This file pertains to "Build the 'No Excuses' QRP Transceiver," by Dan Metzger, K8JWR (QST, Dec 2002, pp 28-34). At the time this was posted, the author's e-mail was **dmetzger@monroe.lib.mi.us**. This file contains an etching pattern and parts-placement diagram for the project with subsequent updates from the author.

NO-EXCUSES TRANSCEIVER - NOTES FOR HOME BREWERS - 7 Dec 02

Figure 10—This is the original parts-placement diagram for the ‘No Excuses’ QRP transceiver with errors. See author’s notes above for corrections.

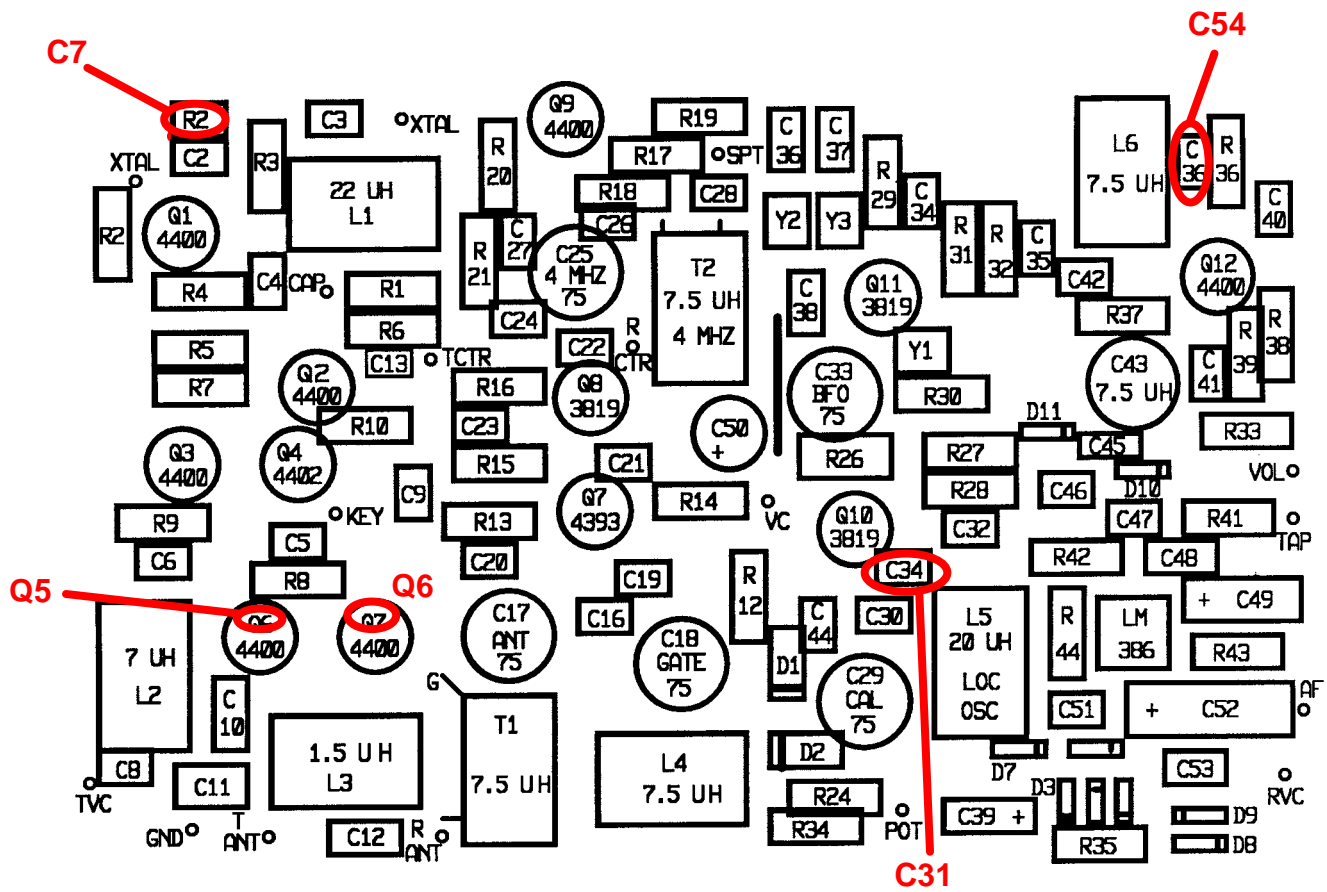
4. The original parts placement diagram on the web contained several errors, hopefully corrected by 10 Dec 02.
 - A. Top left: component above C2 is C7 (not R2)

- B. Top right: component to left of R36 is C54 (not C36)
 - C. Bottom left: components above L3 are Q5 and Q6 (originally mismarked Q6 and Q7).
 - D. Middle right: below Q10 is C31 (not C34).
